Response to a Request for Further Information

**In respect of SDCC Reg. Ref.: SD21A/0162 which
relates to a Warehouse Development at**

Brownsbarn, Citywest Campus, Dublin 24

February 2022

Figure 1.1: Site Plan Proposed at Planning Application Stage (Left) and Site Plan Now Proposed at RFI Stage (Right)

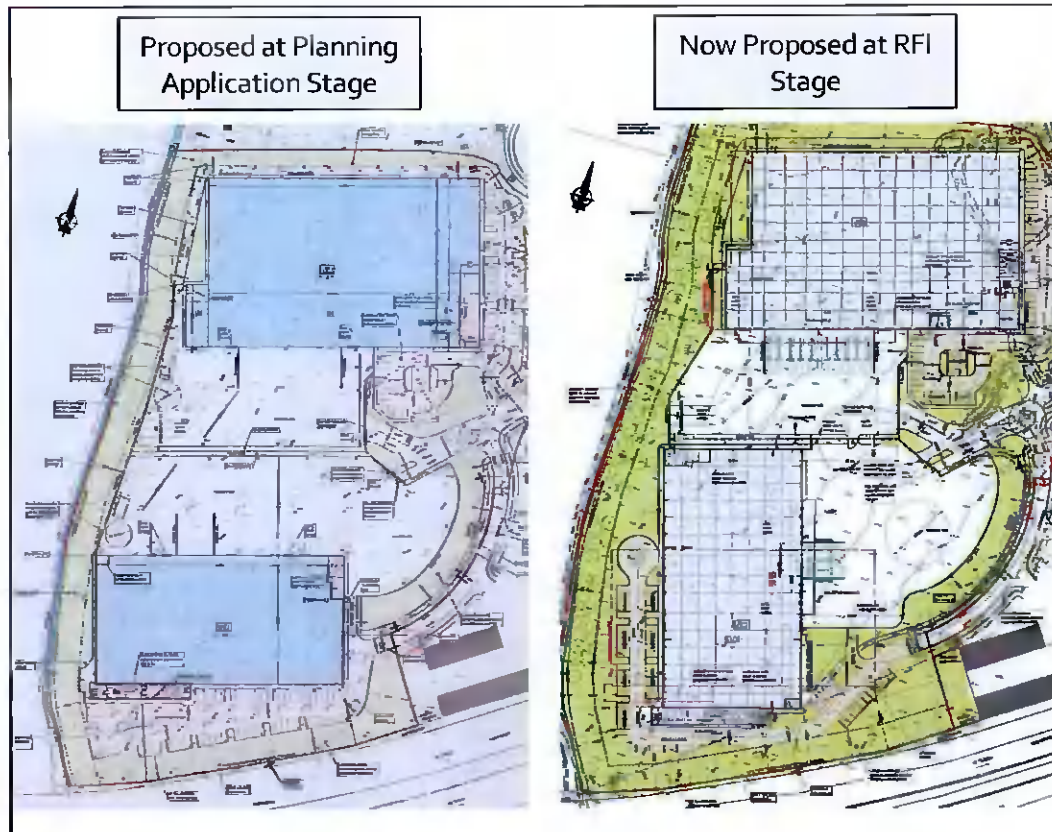
- The floor area of the proposed warehouse unit No. 1 has been reduced from 8,156 sq m to 7,742 sq m to provide an increased landscape area from an average of 10m to between 19.06m and 23.95m wide along the western boundary.

- The alignment of the proposed warehouse no. 2 has been rotated through 90 degrees in order to provide a greater separation distance to the proximate Protected Structure and the majority of the parking areas have been relocated from the previously proposed southern side of the building to the western side in order to allow the substantive parking areas to be screened by the mass of the building.

- The floor area of the proposed warehouse no. 2 has increased from 5,990 sq m to 6,163 sq m. The area of landscaping to the south has been augmented with a significant increase in planting. The landscape zone along the western boundary has increased from an average of 10m proposed at Planning Application stage to between 15.56m and 19.04m in width as part of this *Response to Request for Further Information*.

- The ground level of Unit 2 has been reduced by 500mm which thus reduces the parapet level by 500mm, which will reduce the impact of the height of the structure relative to the adjacent Protected Structure.

Figure 2.1: Landscape Masterplan Proposed at Planning Application Stage (Left) and Landscape Masterplan Now Proposed at RFI Stage (Right) Showing Increased Screening Along Southern Boundary

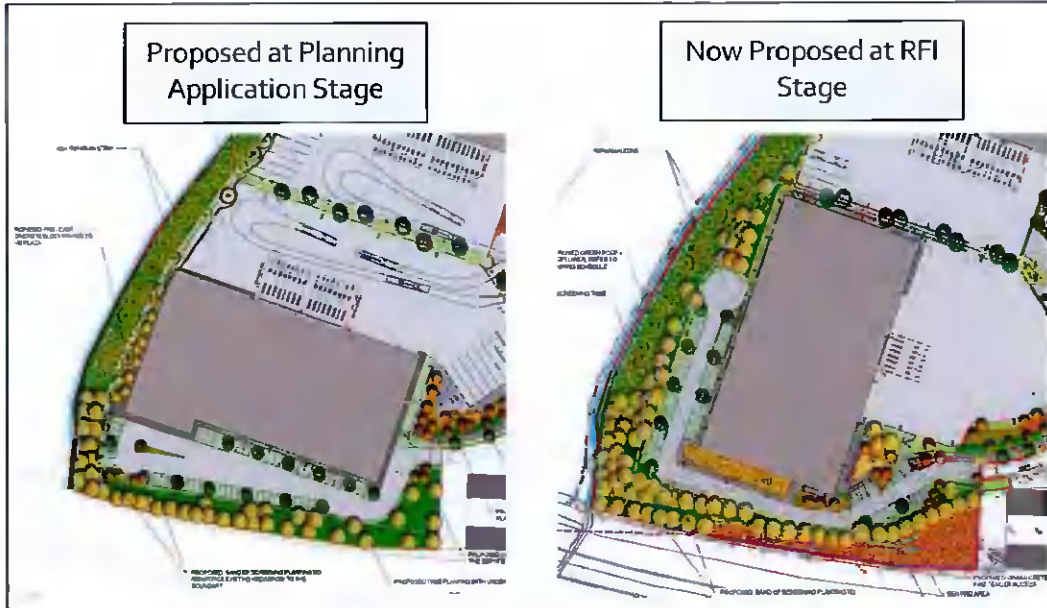
'A 10 m 'buffer' has been proposed along the western boundary, to the east of the stream along this boundary. This is described as a no build zone, and it is proposed to retain the existing vegetation within this. The Planning Authority notes this boundary is significantly vegetated, even beyond 10 m from the stream. Based on the site analysis, and the reports from the Public Realm and Heritage sections, it is considered that in this case 10 m is insufficient to maintain and protect this green corridor. The applicant is requested to review and extend this buffer significantly eastwards having regard to the protection of the existing vegetation along this boundary and of protected species (based on additional site surveys). The proposed lighting plan should be revised with regard to this buffer and the results of the ecological surveys and relocated away from the western ecological area.'

For Unit 1: The landscape area has been increased from an average of 10m to between 19.06m and 23.95m along the western boundary.

For Unit 2: The building has been repositioned and now provides an enlarged landscape zone to the west increasing from an average of 10m proposed at Planning Application stage to between 15.56m and 19.04m in width as part of this *Response to Request for Further Information*.

The '**Landscape Masterplan**' proposed at Planning Application Stage and '**Landscape Masterplan**' now proposed have been included below for reference in order to demonstrate the additional planting along the southern and western boundaries.

Figure 2.2: Tree Pit Detail Drawing

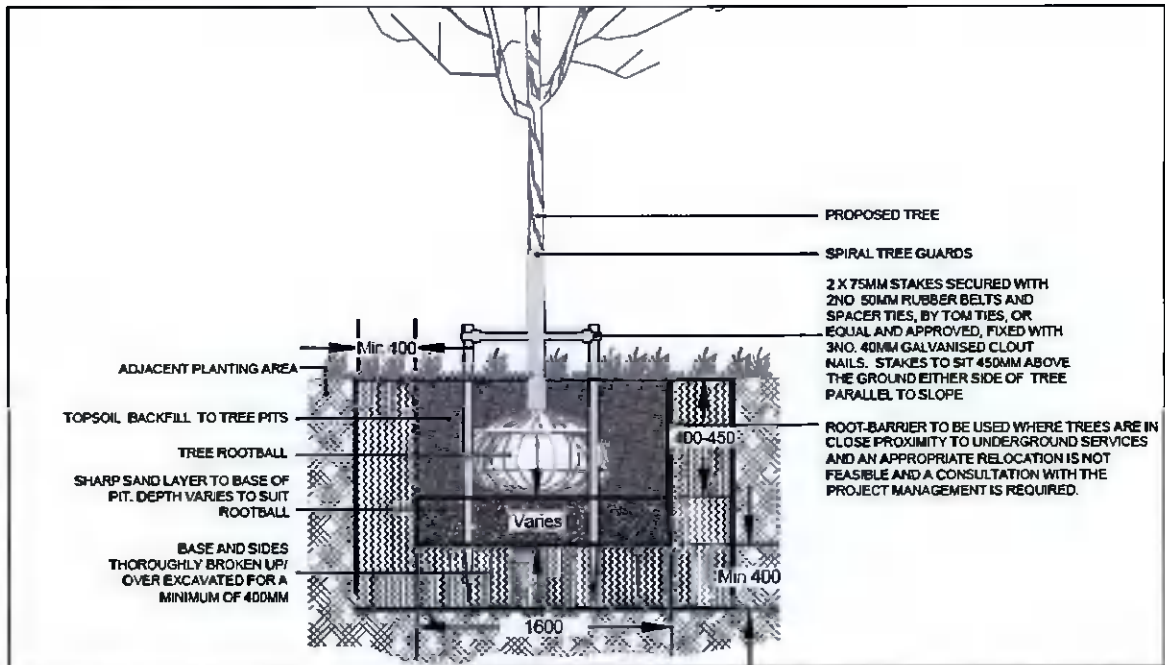
I. More trees to break up the car park hard standing areas in the North East. A tree every 5 parallel and 2 perpendicular car park spaces is required ensuring 5m separation from lighting columns. All car park trees and trees adjacent to hard standing should incorporate SuDS tree pits.

All car park trees and trees adjacent to hard standing incorporate SuDS tree pits, as shown on the 'Landscape Masterplan' drawing (Drawing No. ENO-JBAI-XX-XX-DR-L-0002). A tree pit detail drawing has been provided below for reference which is contained within the enclosed 'Landscape Masterplan' drawing prepared by JBA Consulting, which states:

'A tree pit detail has been added into the carpark design which adjacent to hard standing surfaces, this will allow incorporated SuDS.'

Figure 2.6: Section C-C Contained within the 'Landscape Section' (Drawing No. ENO-JBAI-XX-XX-DR-L-0004)

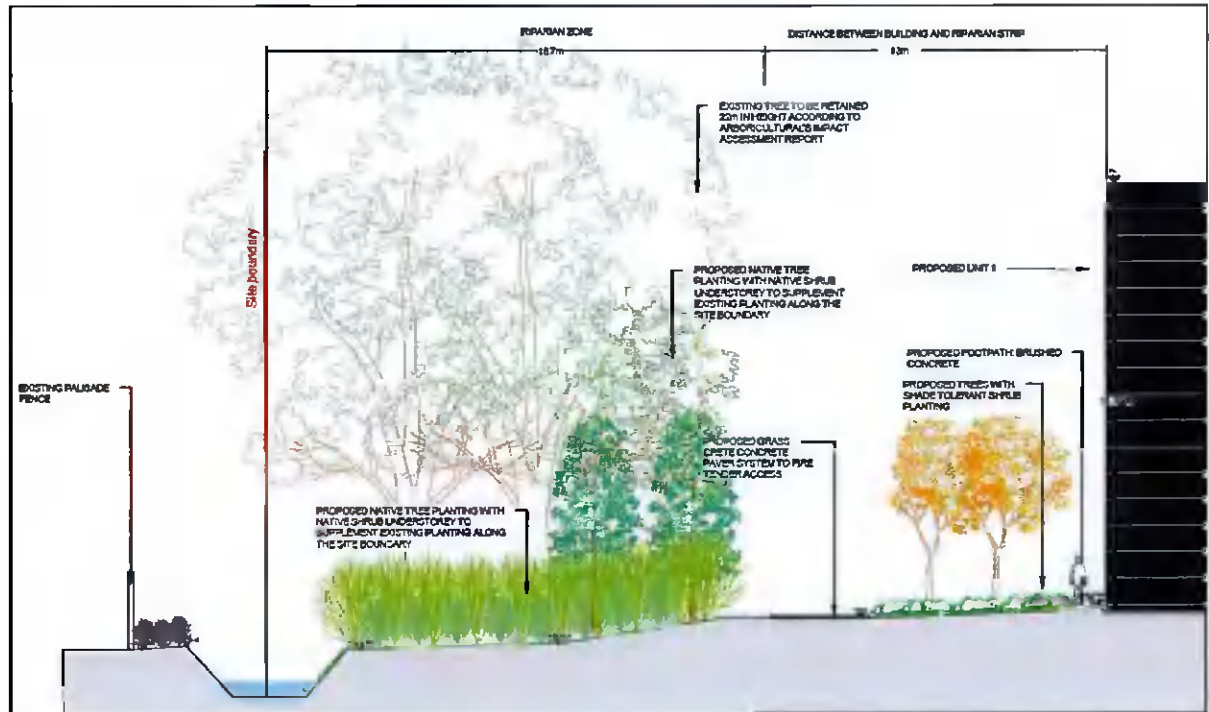
b) The Planning Authority has concerns in regard to the use of the proposed material open texture macadam for the fire tender access and car parking areas when a more greened material would be more appropriate. This might include the use of grasscrete or similar. The applicant is requested to submit revised proposals for 'greened' pathway solutions and submit revised cross sections clearly showing any revised materials and associated drainage.

The design team have sought to reduce open texture macadam for the fire tender access and car parking areas. As part of this *Request for Further Information Response*, grasscrete has been provided in car parking areas and fire tender access and permeable paving is proposed for the disabled car parking spaces and internal road space. Please refer to the

Please also refer to the enclosed Landscape 'Section C-C' drawing contained within the 'Landscape Section' (Drawing No. ENO-JBAI-XX-XX-DR-L-0004) which shows revised cross sections showing revised materials and associated drainage, as shown below:

Figure 2.8:
Fence Type A – Paladin Fence

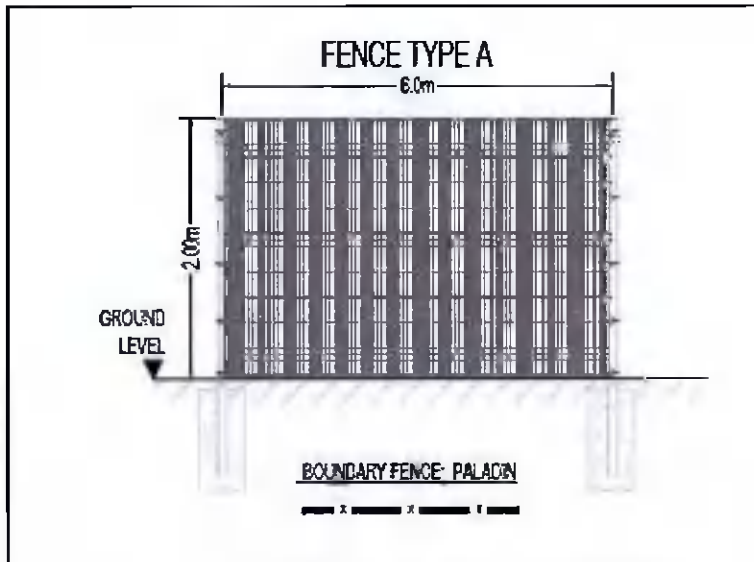
'The applicant is requested to provide details of Fence Type A and B and of fencing types along all boundaries. A boundary plan is required clearly stating what fencing/boundary wall treatments are to be provided. The applicant should note that interference with the existing stone wall would not be acceptable to the Planning Authority.'

Details of Fence Type A and Fence Type B have been extracted from the 'Boundary Plan' Drawing (Drawing No.: D1678 D3-2 PL1) and are included below for reference. It is important to note the existing stone wall will not be interfered with and is listed as Fence Type B in the below Figure 2.9.
